- 10.** Address/Description: 362 E HUISACHE AVE
HDRC Case No.: 2024-404
Historic District Name: Monte Vista
Neighborhood Assn Name: Monte Vista Historical
Applicant: Anthony Chen/Aeonium Investments LLC
Request: Conceptual review for rear detached garage construction
City Council Dist.: 1

HISTORIC AND DESIGN REVIEW COMMISSION

December 18, 2024

HDRC CASE NO: 2024-404
ADDRESS: 362 E HUISACHE AVE
LEGAL DESCRIPTION: NCB 3088 BLK 4 LOT 15
ZONING: R-4, H
CITY COUNCIL DIST.: 1
DISTRICT: Monte Vista Historic District
APPLICANT: Anthony Chen/Aeonium Investments LLC
OWNER: BEAM GREGORY & ALISON
TYPE OF WORK: Conceptual review for rear detached garage construction
APPLICATION RECEIVED: November 25, 2024
60-DAY REVIEW: January 24, 2025
CASE MANAGER: Bryan Morales
REQUEST:

SITE PLAN & FLOOR
PLAN

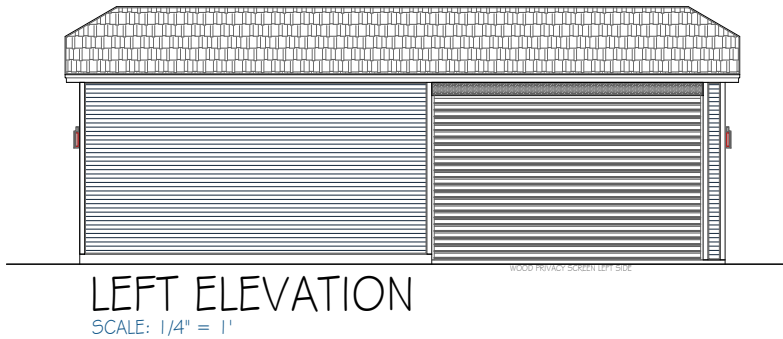
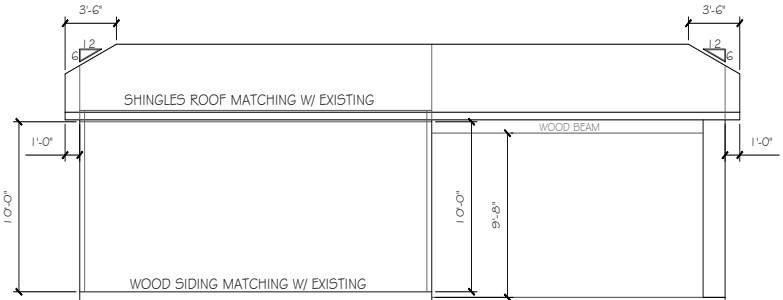
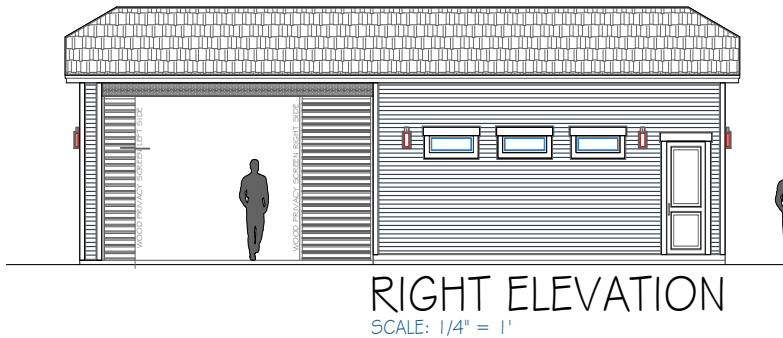
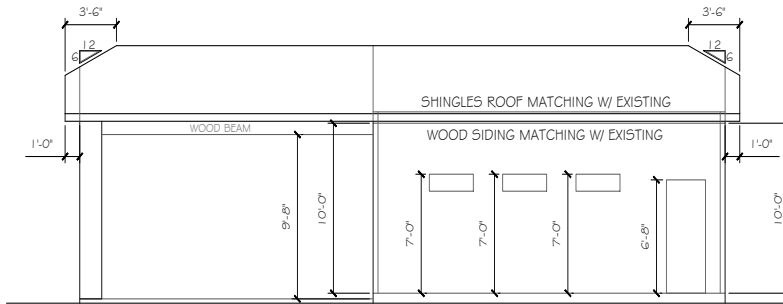
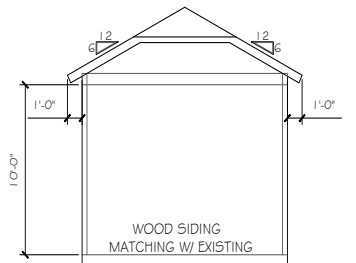
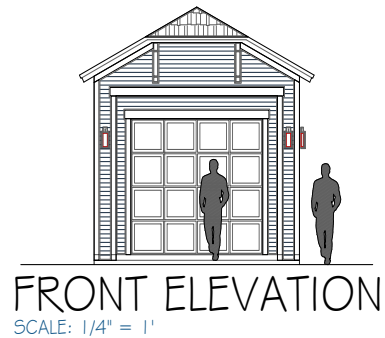
- b. NEW CONSTRUCTION (REAR ACCESSORY STRUCTURE) – The applicant is requesting conceptual approval to construct an approximately 360 sf 1-story accessory structure at the rear of the property. The Guidelines for New Construction 5.A. notes that new outbuildings should be visually subordinate to the primary historic structure in terms of their height, massing, and form, and should be no larger in plan than forty percent of the primary historic structure's footprint. The existing primary structure on the lot features a footprint of approximately 2,230 square feet and one story in height. The proposed 1-story accessory structure features a total footprint of approximately 360 square feet, or approximately 16% of the primary structure's footprint. Accessory structures on the block are predominately single story. Staff finds the proposed height and general massing conforms to Guidelines.

- c. ORIENTATION & SETBACKS – The applicant has proposed both an orientation and setback for the new accessory structure that are consistent with the Guidelines for New Construction 5.B.

A-2
ELEVATIONS

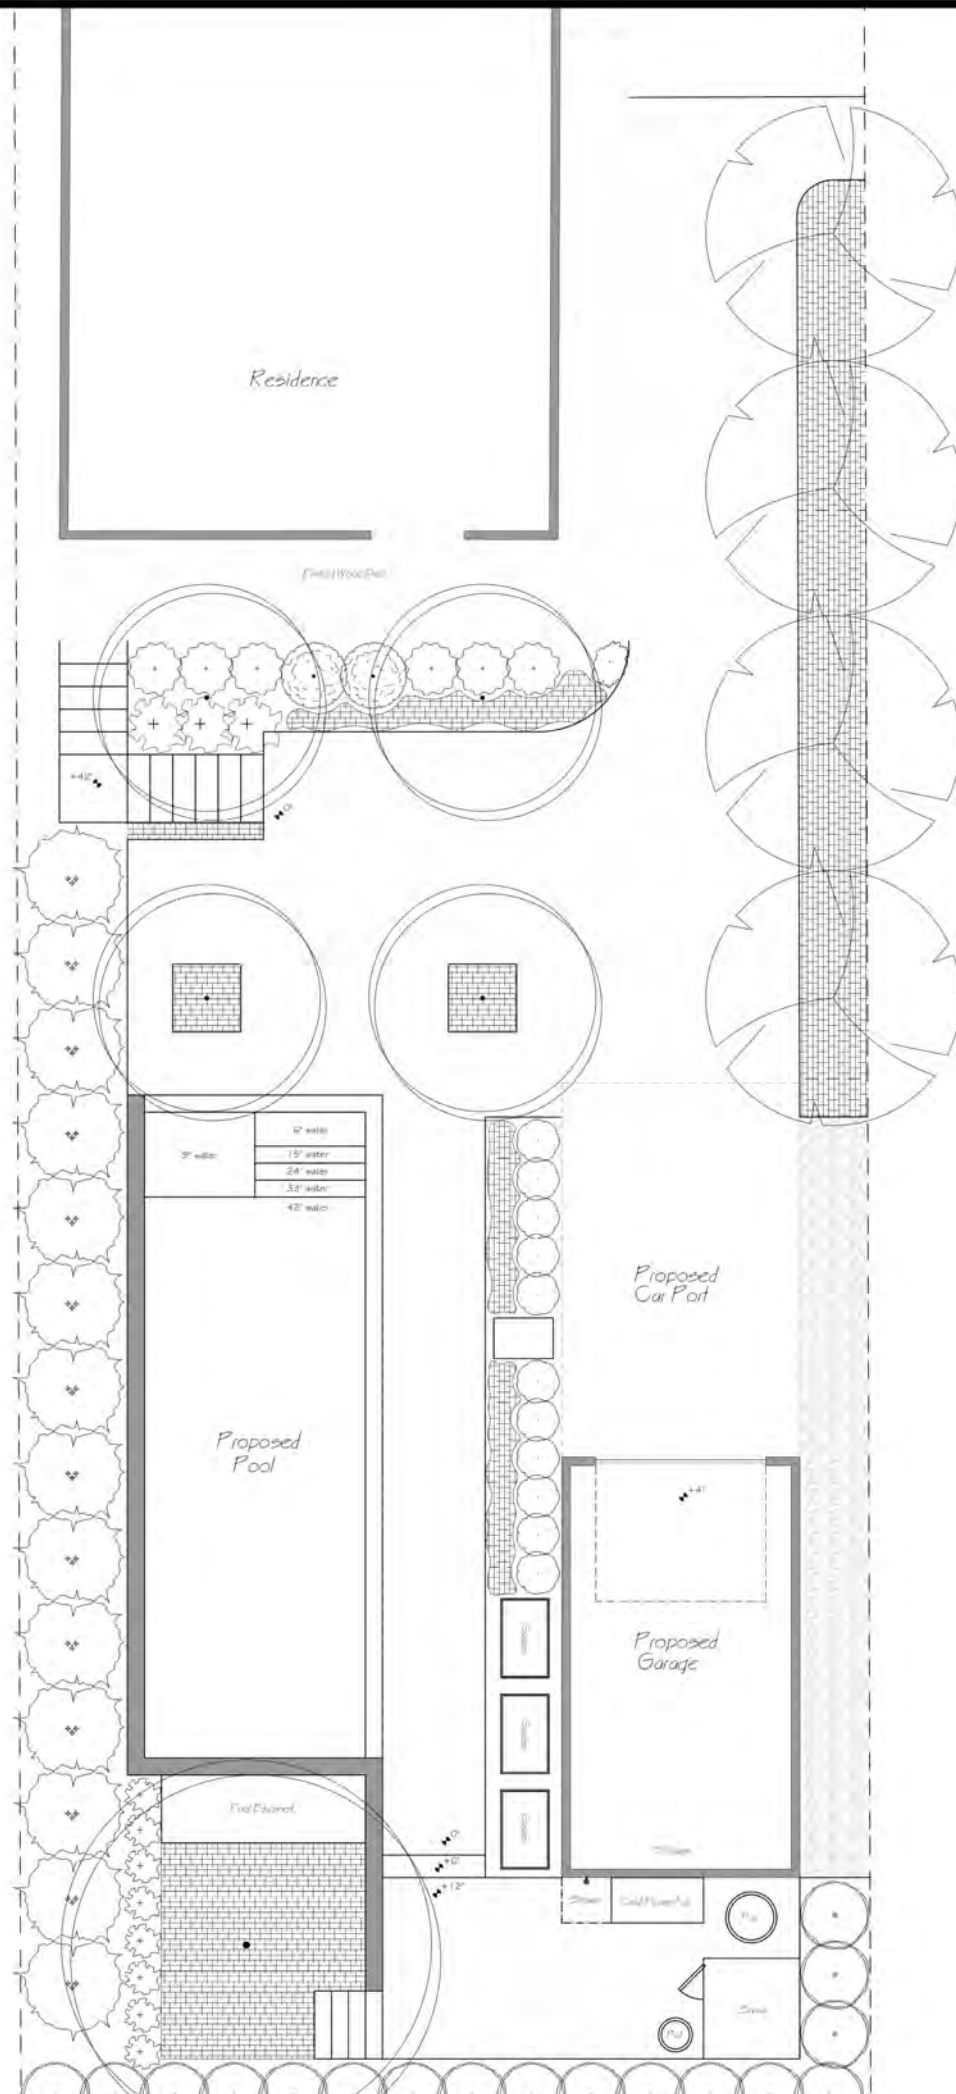
- d. ARCHITECTURAL DETAILS – The applicant is requesting conceptual approval to construct a 1-story accessory structure at the rear of the property featuring a roof vent, Craftsman roof brackets, and louvered wood wall sections. The Guidelines for New Construction 5.A.iii. and 5.A.iv. note that new accessory structures should relate to the period of construction of the primary historic structure on the lot by using complementary materials and simplified architectural details. Staff finds the roof vent, roof brackets, and louvered wood wall sections generally appropriate.

- e. ARCHITECTURAL DETAILS (MATERIALS) – The applicant is requesting conceptual approval to construct a 1-story accessory structure at the rear of the property with a composition shingle roof and 117 wood siding. The Guidelines for New Construction 5.A.iii. and 5.A.iv. note that new accessory structures should relate to the period of construction of the primary historic structure on the lot by using complementary materials and simplified architectural details. Staff finds the proposed composition shingle roof generally conforms to Guidelines. Staff finds the installation of 117 wood siding generally conforms to Guidelines. New Construction 2.B.i states that roof forms—pitch, overhangs, and orientation—consistent with those predominately found on the block should be incorporated. Staff finds the proposed hip-on-gable roof and its pitch conforms to Guidelines.

- f. ARCHITECTURAL DETAILS (FENESTRATION PATTERN) – The applicant is proposing to install one Craftsman wood door on the right façade, one garage door on the front façade, and three clerestory windows on the right façade. The Guidelines for New Construction 2.C.i. related to window and door openings stipulates to incorporate window and door openings with a similar proportion of wall to window space as typical with nearby historic facades. Staff finds the proposed fenestration pattern generally appropriate; however, the applicant should incorporate single-sashed windows on the right façade rather than the requested clerestory windows.

- g. WINDOWS (MATERIALS) – The applicant has not provided material information on the proposed windows on the right façade. Per *Standard Specifications for Windows in New Construction*, new windows on new construction should relate to the windows of the primary historic structure in terms of materiality and overall appearance. Windows used in new construction should be similar in appearance to those commonly found within the district in terms of size, profile, and configuration. Staff recommends that the applicant install wood or aluminum-clad wood windows on the rear accessory structure. An alternative window material may be proposed, provided that the window features meeting rails that are no taller than 1.25" and stiles no wider than 2.25".

- i. That the applicant installs a fully wood or aluminum-clad wood window that meet staff's standard window stipulations and submits updated specifications to staff for review and approval. The windows should feature an inset of two (2) inches within facades and should feature profiles that are found historically within the

immediate vicinity. Meeting rails must be no taller than 1.25” and stiles no wider than 2.25”. White manufacturer’s color is not allowed, and color selection must be presented to staff. There should be a minimum of two inches in depth between the front face of the window trim and the front face of the top window sash. This must be accomplished by recessing the window sufficiently within the opening or with the installation of additional window trim to add thickness. Window trim must feature traditional dimensions and architecturally appropriate sill detail. Window track components must be painted to match the window trim or concealed by a wood window screen set within the opening.

- ii. That the applicant install a fully wood garage door or a garage door with a design that mimics wood construction and features a smooth finish without a faux wood grain texture. Final garage door specifications must be submitted to staff for review and approval prior to the issuance of a Certificate of Appropriateness.
- iii. That the applicant meets all setback standards as required by city zoning and obtain a variance from the Board of Adjustment if applicable.
